Re: **129 W. Genesee Street Splash Car Wash – Site Plan Review**

The following letter has been written in response to the review comments from Napierala Consulting dated August 18, 2022, received from the Village of Fayetteville on August 24, 2022. The following comments have been addressed below.

DRAWING TITLE:
EXISTING CONDITIONS AND DEMOLITION PLAN

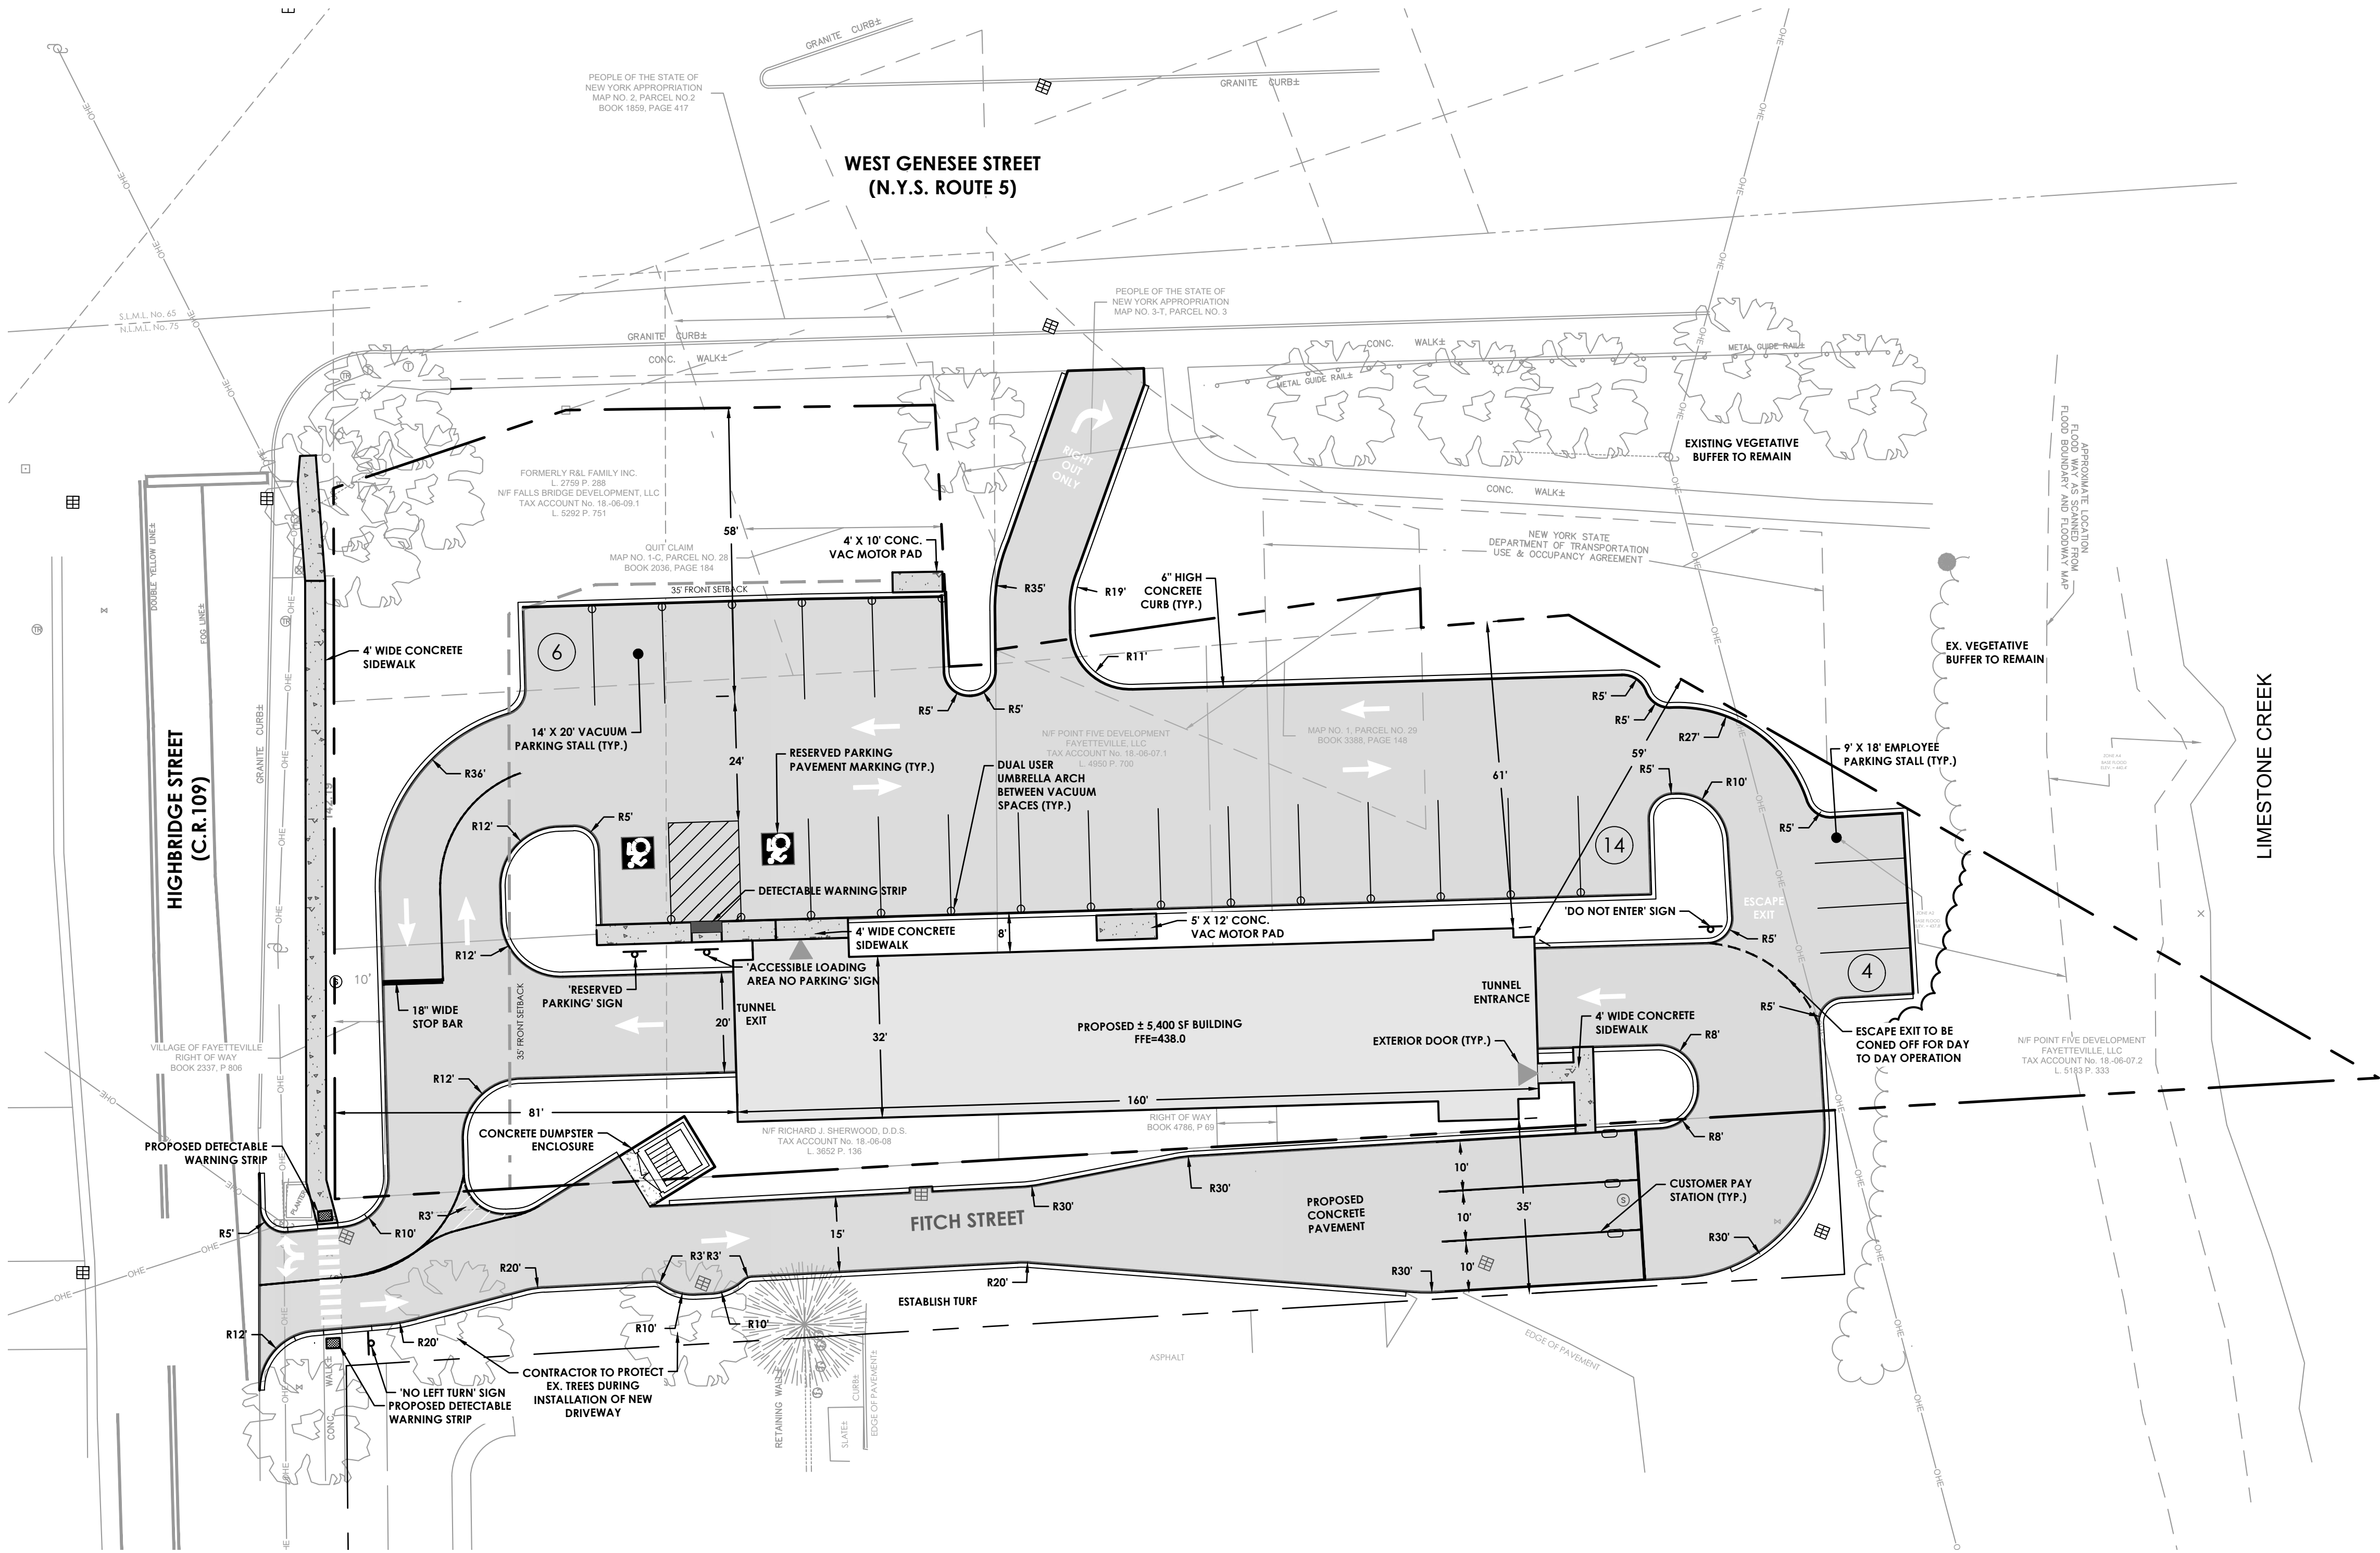
1) Existing Conditions and Demolition Plan, C2

- a. The existing conditions should include a current survey by a licensed land surveyor
Please see Existing Features survey map Sheet C2.
- b. The plans should include typical demolition notes, including but not limited to:
 - i. Coordinate all waterline removals with OCWA
 - ii. Coordinate all sewer removals with OCWEP
 - iii. Coordinate all power removals with National Grid
 - iv. All work within the right of way requires a permit from NYSDOT and OCDOT
 - v. Tree identified to remain on C3 should be shown on the demolition plan and noted/detailed with tree protection

Please see revised Existing Conditions and Demolition Plan sheet C2A.

REV: 01	DRAWING NO: C3
---------	----------------

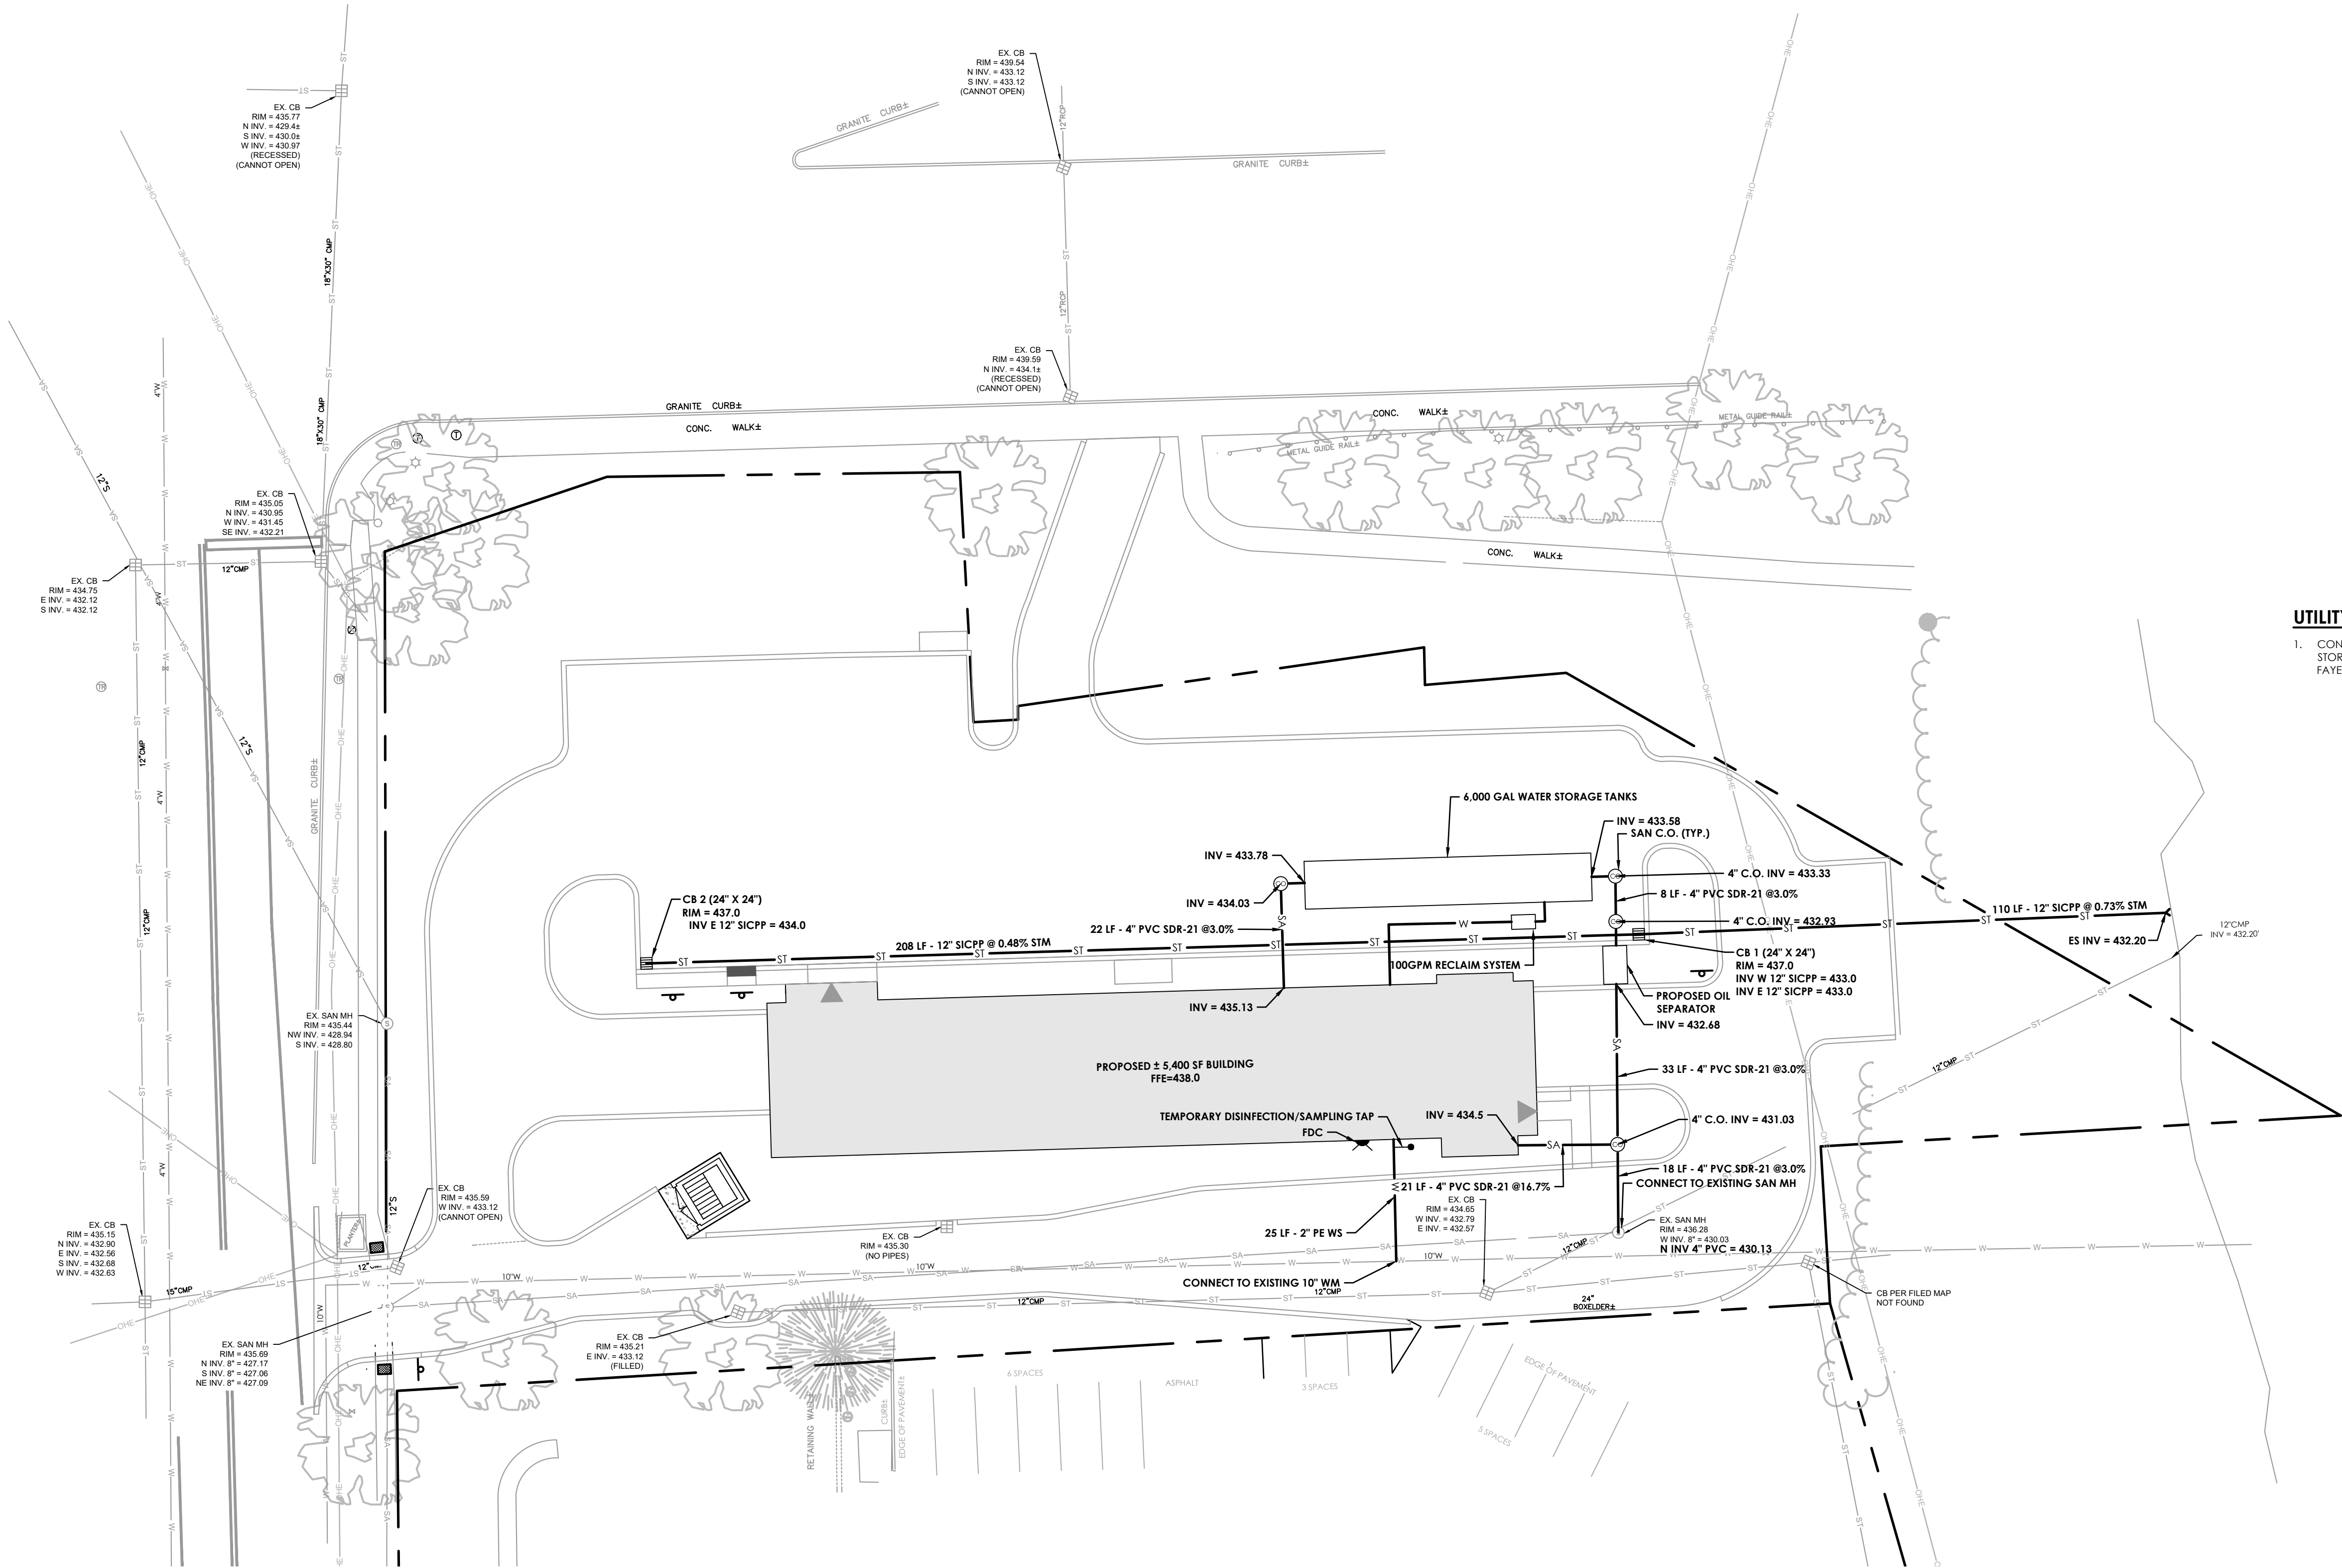
2) Site Plan, C3

- a. Provide an accessible aisle, signage and curb ramps with details, per ADA requirements.
Please see revised Site plan.
- b. Provide delivery/vendor/garbage truck circulation path on the plan for review.
Turning movement sheet will be provided in the near future.

- c. Coordinate review of firetruck/EMS access with the Village of Fayetteville Fire Department
Comment acknowledged.
- d. Suggest the use of way signs, including but not limited to:

- i. "Do Not Enter" at escape exit area for southbound patrons
 - ii. Directional sign at tunnel exit to direct traffic to Highbridge Street for eastbound Route 5 Traffic

- iii. No left turn sign for traffic upon entering from Highbridge Street***Please see revised Site Plan.***
- e. Encroachments appear in NYSDOT right of way (parking spaces, dumpster, vac motor pads, etc)
Site layout had been revised, no encroachment in NYSDOT right of way is currently proposed.

- f. Identify quantity of stacking vehicles/queue length. How does the queue length relate to the expected traffic generation?
The site has the ability to have 30 vehicles stacked in the queue.

- g. Identify limit of proposed concrete pavement noted near the pay stations vs. asphalt pavement.
Concrete pavement will be used throughout the entire site.

- h. Regarding the vacuum motor pad, what is mounted on it? Is visual screening necessary?
The vacuum motor producer and filter separator are mounted on the motor pad. Please see details and cutsheets included with this comment response letter.
